Cheyenne Passenger Rail Station Site Selection Study

Railroad Operations, Infrastructure Modifications, and Station Concepts Technical Memorandum

January 2025

Figure 2 Old Happy Jack Road Passenger Rail Station Concept Plan

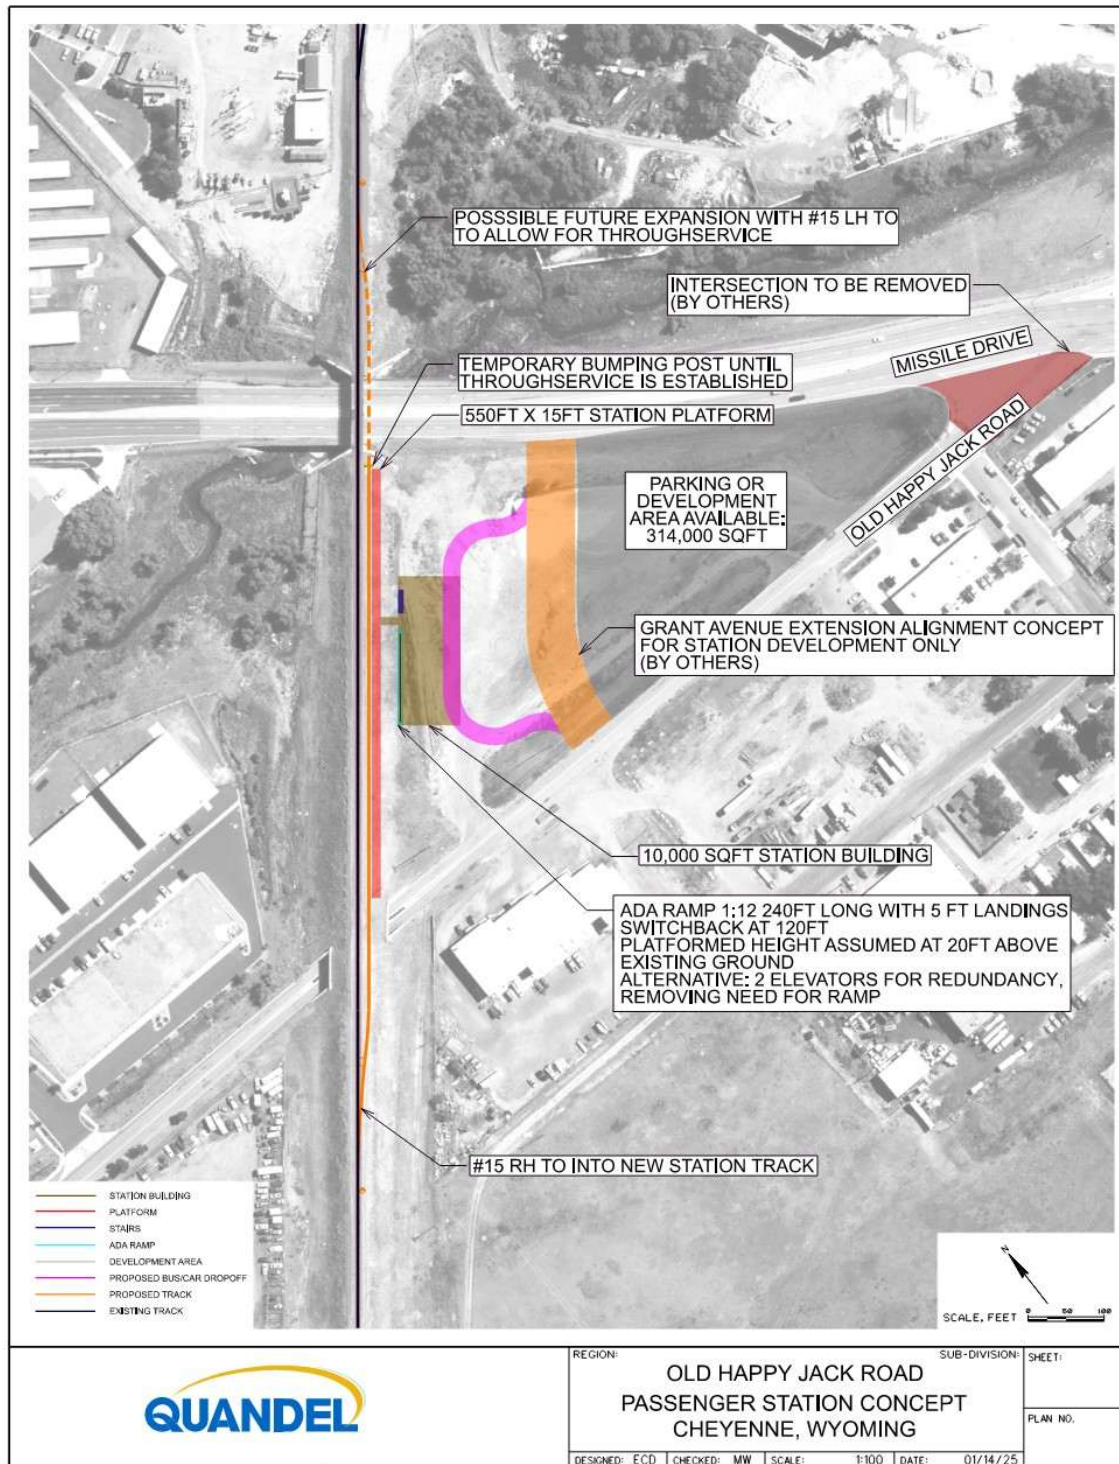
- Charles reviewed the Old Happy Jack Road concept.
 - John agreed with the decision to implement a stub end station track with a bumping post. In general, BNSF prefers options that have the fewest modifications to their mainline track, adding that this option could help streamline BNSF approvals.

Figure 4 Reed Avenue Corridor Passenger Rail Station and Steam Plant Integration Concept Plan

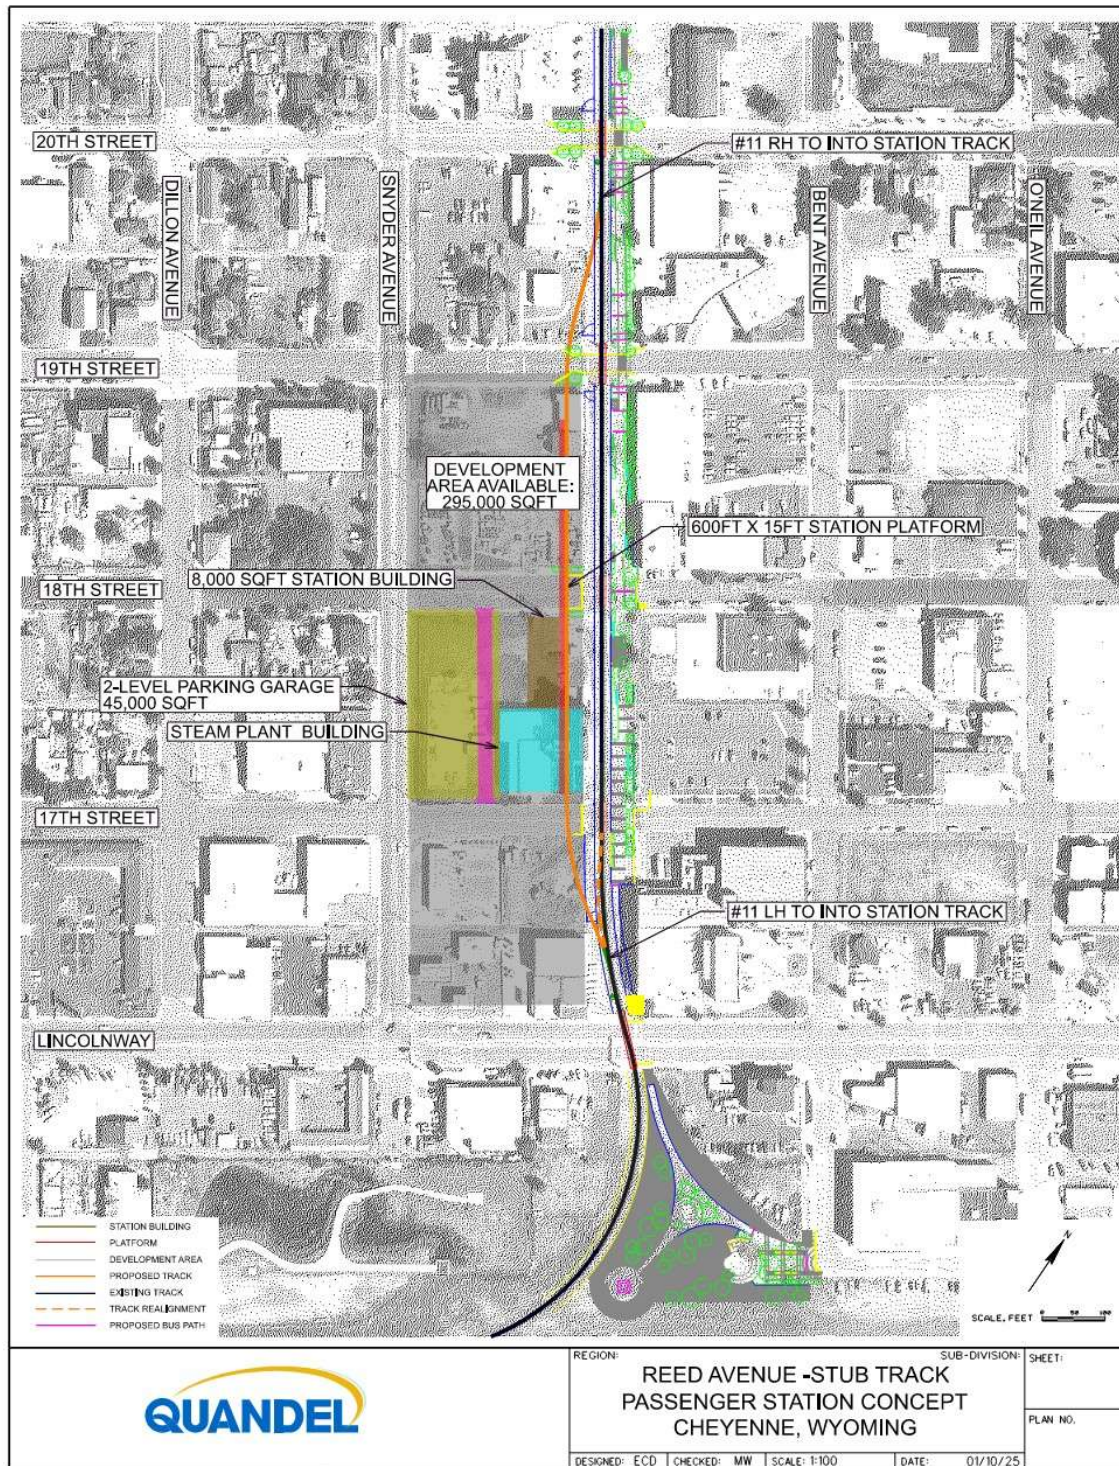
- Charles reviewed the Reed Avenue Steam Plant concept.
 - Amber asked if BNSF had provided input on the track design. Highlighting that a #10 turnout isn't typically used by them.

- Amber expressed concerns with the track geometry, noting that modifications to BNSF's alignment may have a domino effect that could alter the remaining leg of their wye connection to UP's tracks.

- Charles reviewed the Reed Avenue Steam Plant concept
 - Charles reported that UP expressed concern with the curved track proposed through 19th Street. Adding that this design would require BNSF to order non-standard specialty crossing panels.

- John pointed out the geometric constraints near the Lincolnway at-grade crossing and cautioned that the change from a #10 to #11 would further complicate this alignment.

Figure 5 Reed Avenue Corridor Passenger Rail Station and Stub Track Concept Plan

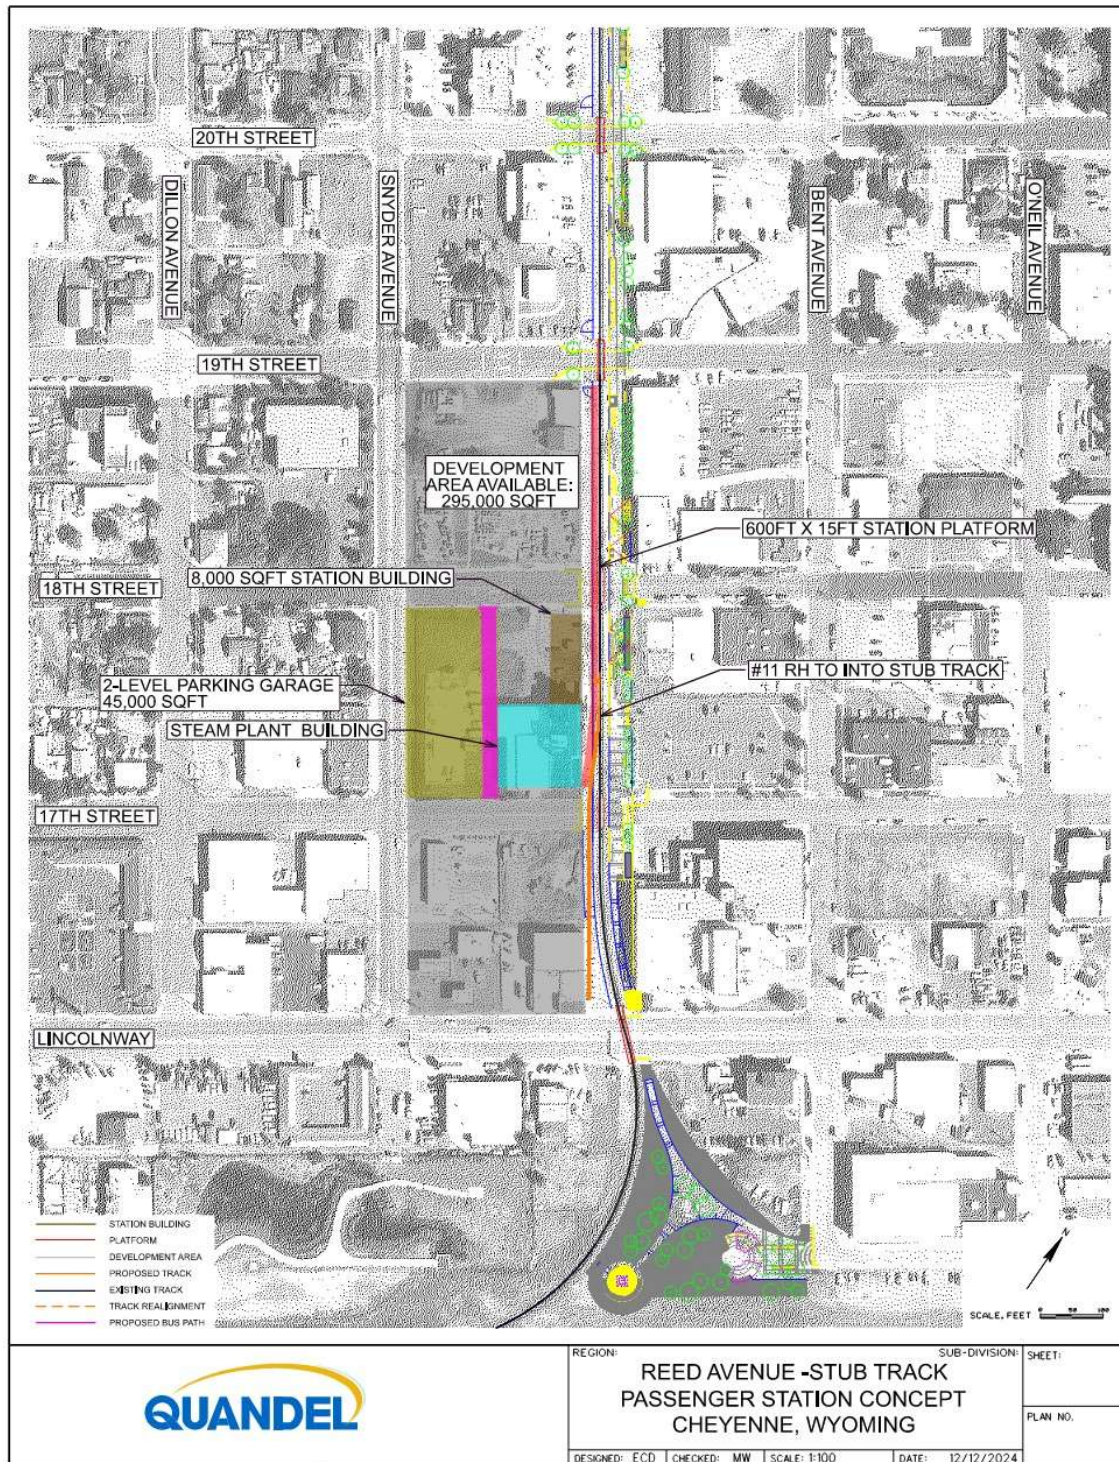
- Charles reviewed the Reed Avenue Stub-Track concept.
 - Mark confirmed that the plan employs 15' track centers.
 - Amber noted the right-of-way width is set by ordinance.

- Mark explained that this plan would use the BNSF's existing track to board an alight customers, and the stub-track would allow trains to clear the mainline while not in service.

- Amber explained that this plan is problematic because it has potential to hinder the rock trains. These trains are unscheduled and needed for critical railroad repairs.
